CITY OF PATASKALA BOARD OF ZONING APPEALS

STAFF REPORT

Transportation Corridor Overlay District TCOD-22-002

TCOD-22-002 Staff Review

**PROVISION LIVING
CITY OF PATASKALA
LANDSCAPE PLAN - SOUTH**

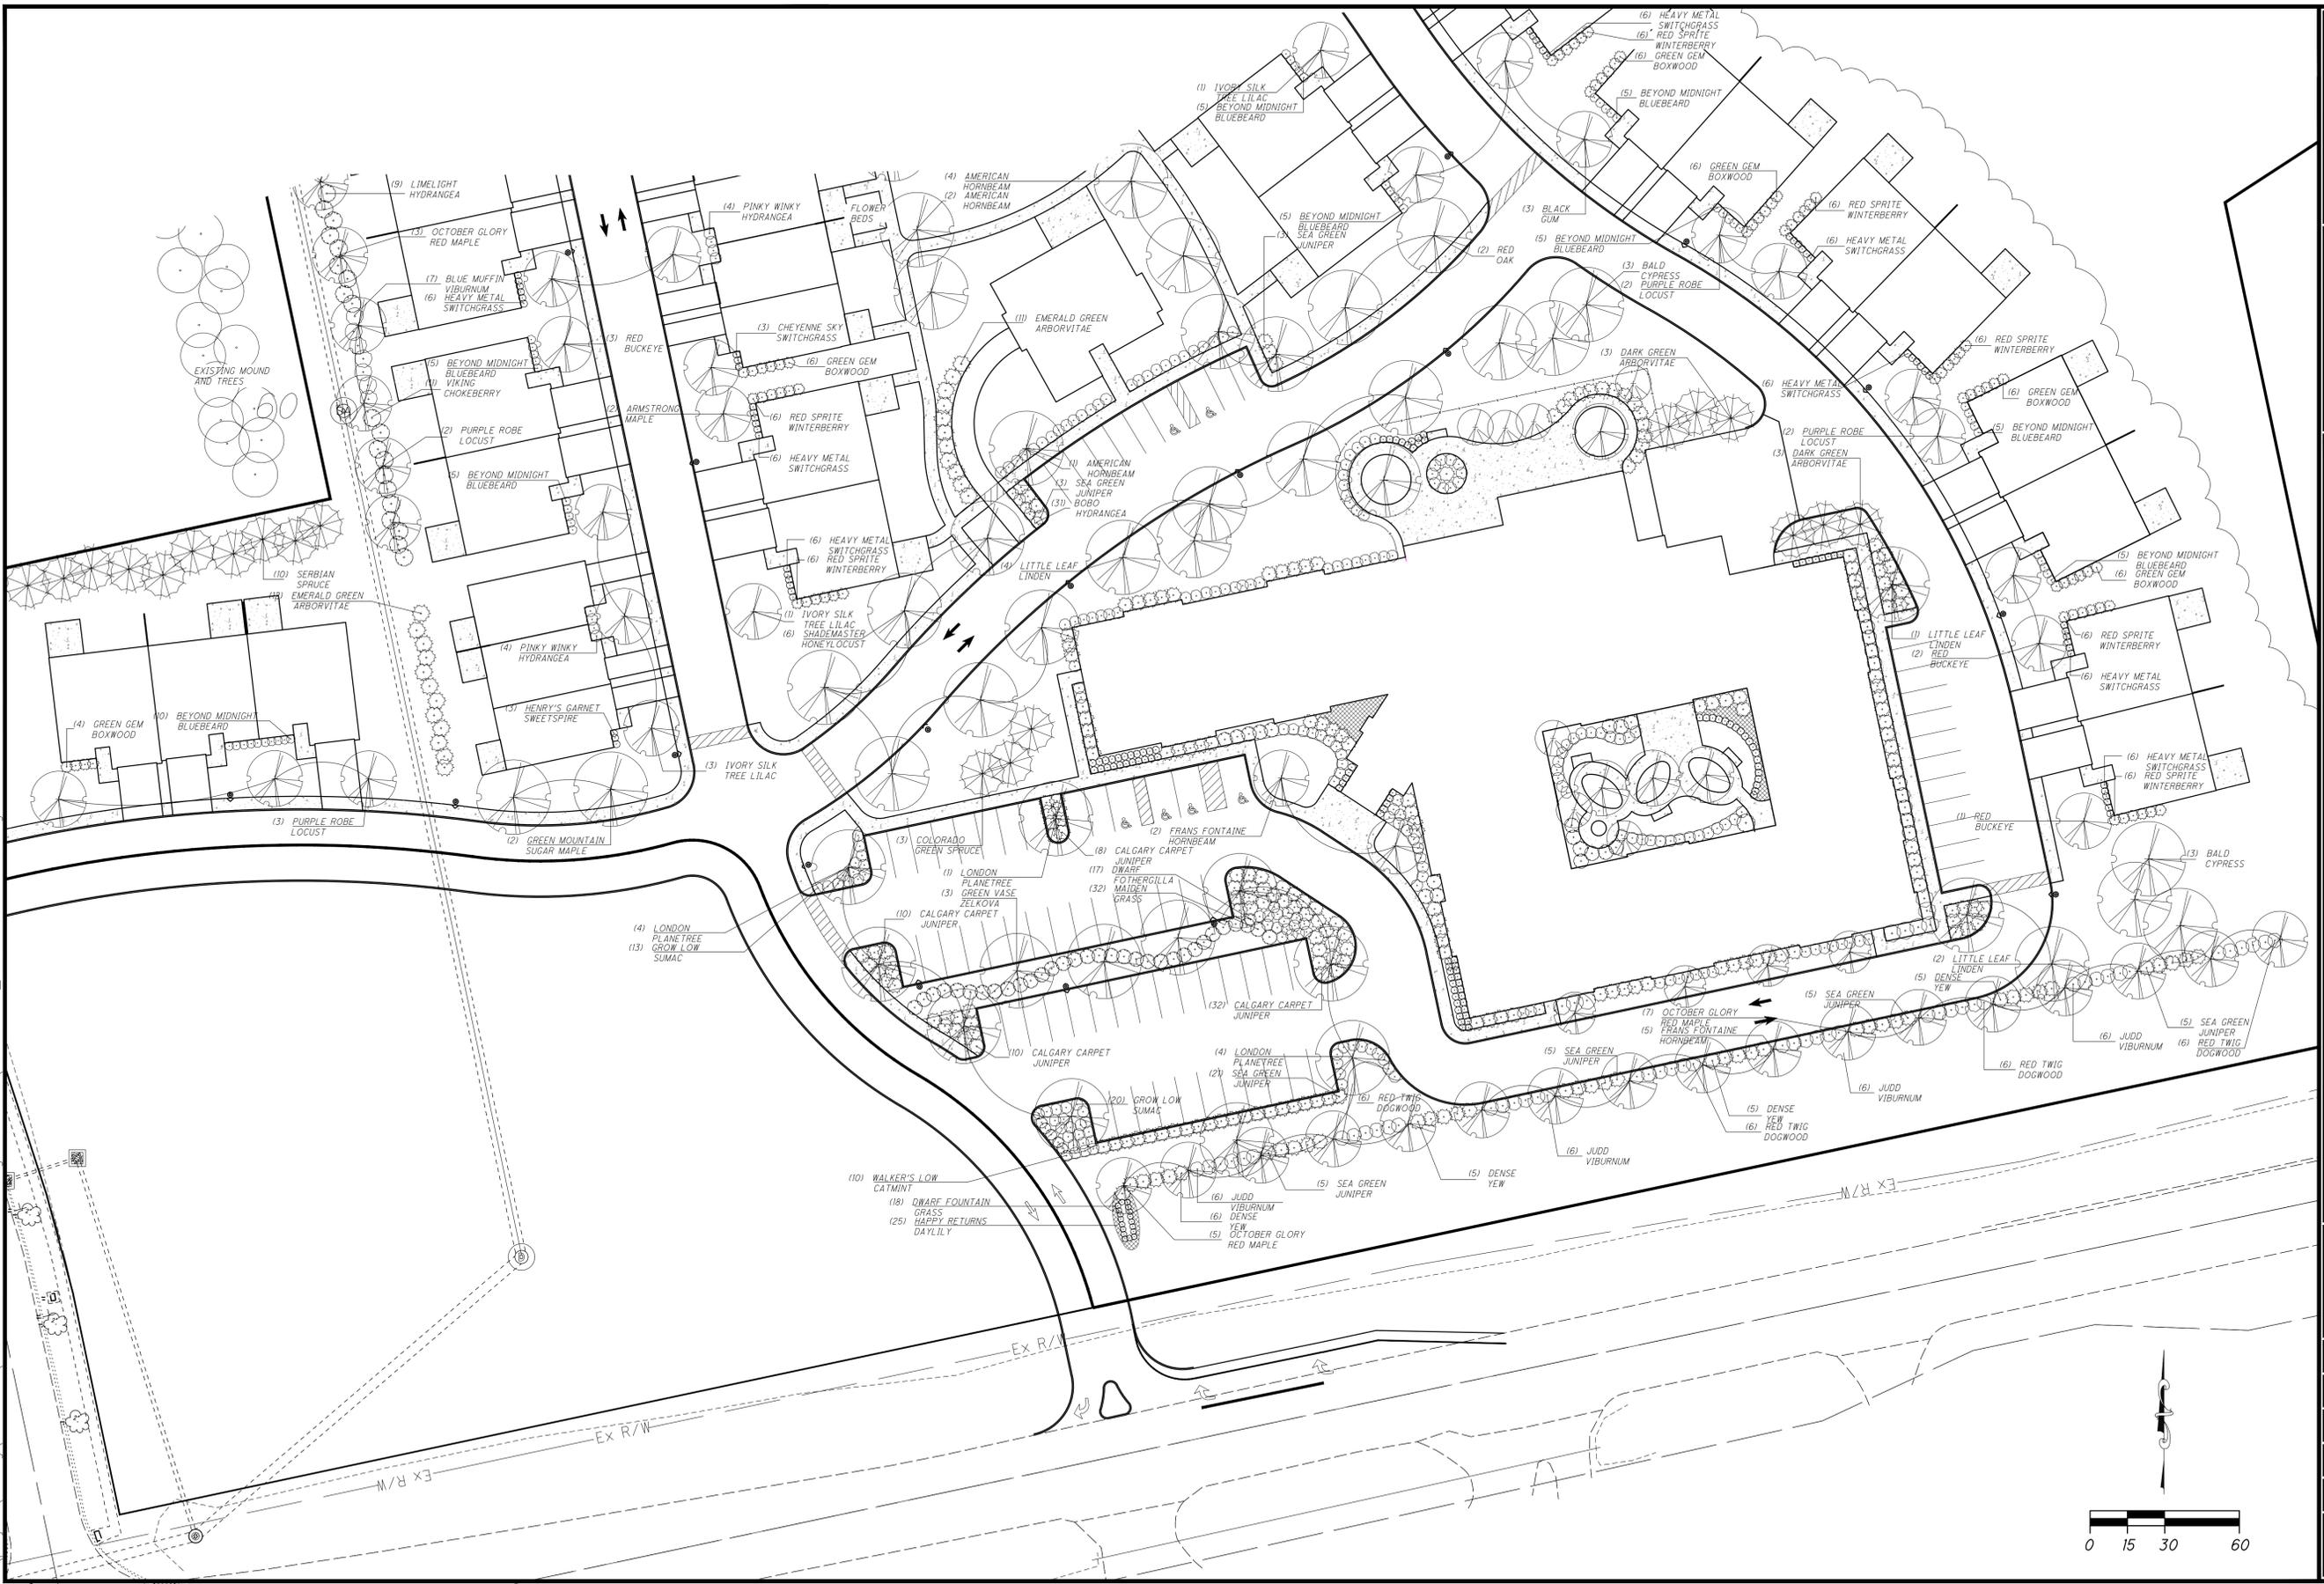
- Heron Avenue Frontage: It appears that the frontage on Heron Avenue is cut-off by the scale of the Landscaping Plans and no screening along this frontage is shown.

- Proposed screening does not meet the L3 or L4 standard. There is an existing mound (6' in height) and trees within the reserve area of Heron Manor. It is the Applicant's belief that the proposed landscaping in combination with that existing within Heron Manor will be sufficient to properly screen the adjoining uses.

- 1283.07 – Application of Landscaping Standards
 - 1283.07(B) for uses within the GB Zoning District:
 - ~~*Front Yard: L2 (any frontage on public R/W)~~
 - ~~L2 shown along south border of parking to west of AL/MC building. No other perimeter screening shown along frontages.~~
 - **West Frontage along Heron Ave: Appears just outside of view on Landscaping Plans, cannot tell if there is any there or not. L2 required.**
 - *Side Yard: L3 or L4 if abutting a residential use (west, abutting Heron Manor. East, adjacent to undeveloped portion)
 - **West: Mix of low shrubs and evergreen/deciduous trees along perimeter of Heron Manor.**

- Does not strictly meet L3 or L4 code, up to PZC to approve.
 - *Rear Yard: L3 or L4 if abutting a residential use (North, along Heron Manor/Settlement of Pataskala)

1 EXTERIOR ELEVATION - WING 'B'
P3 1/16" = 1'-0"

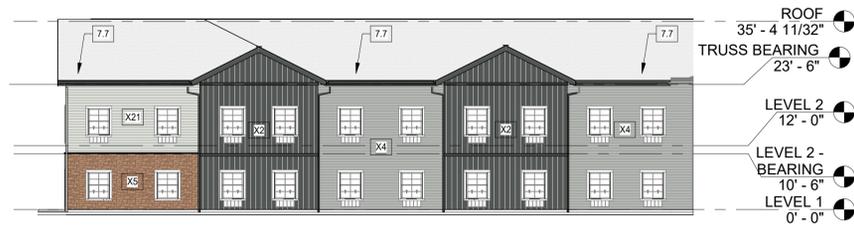
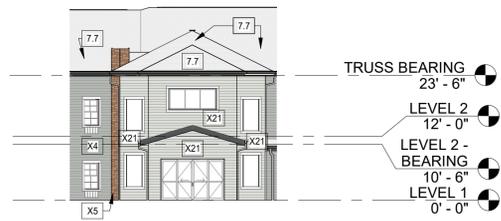
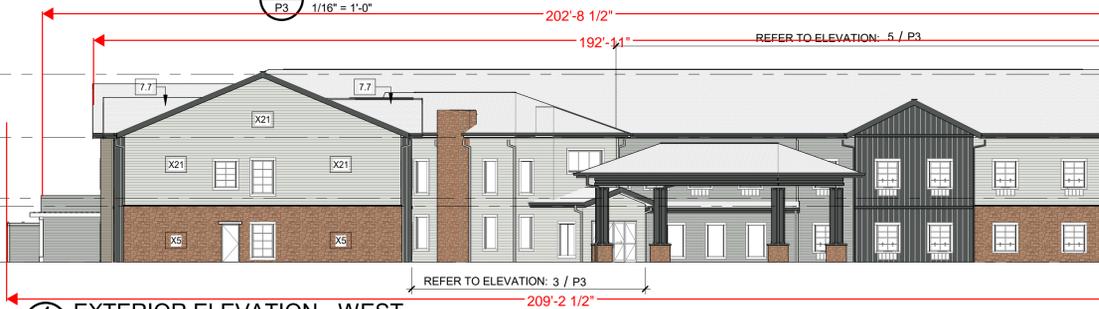
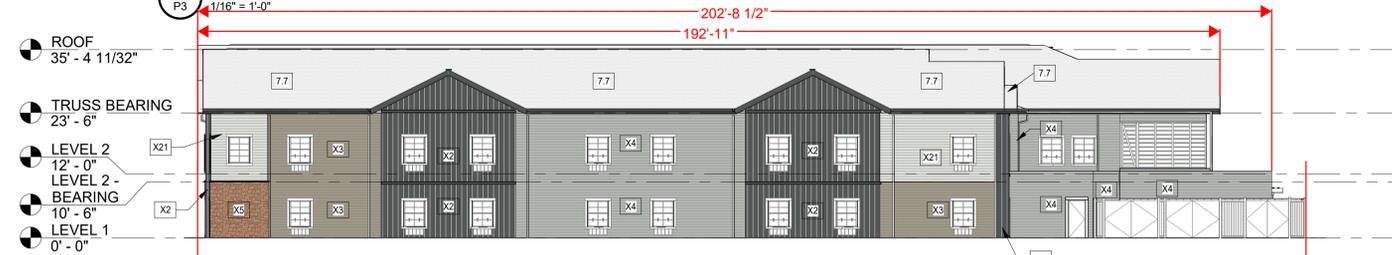
- The proposed building height exceeds the 35' maximum height permitted by Section 1249.05(A) by 4-11/32". The Planning and Zoning Commission is unable to approve as proposed, so a Variance will be needed.

- 1249.05 – General Requirements of the GB District
 - 1249.05(A): Maximum building height is 35-feet.
 - Proposed building height exceeds max at 35'-4 11/32".

- Will need a Variance for this. Height deviations not allowed under TCOD.
 - 1249.05(C): Setbacks and Yards
 - ~~*1249.05(C)(1): Front Yard shall be 50' in depth when serviced by central water and sewer.~~

ELEVATION - DOUBLE SIDED SIGN

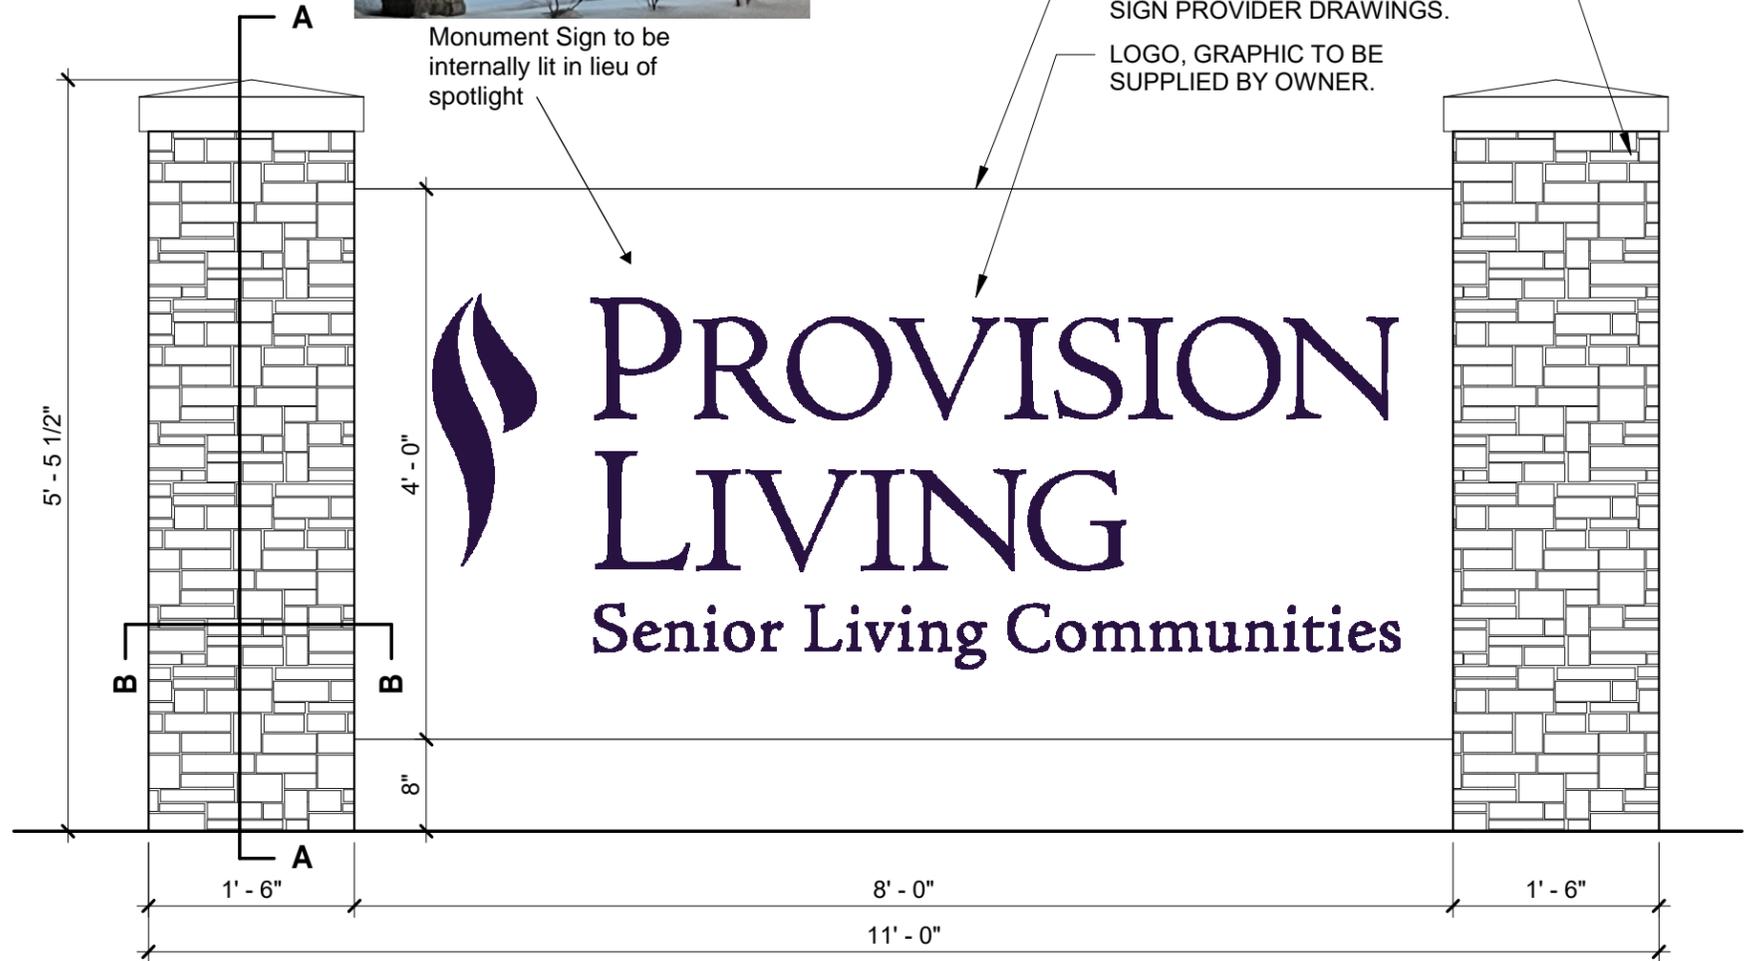
- Sign: size and height okay.
 - Illumination: so long as just the letters are illuminated and not the entire sign (no full face lit cabinet) then that is okay. Appears to be based on rendering.
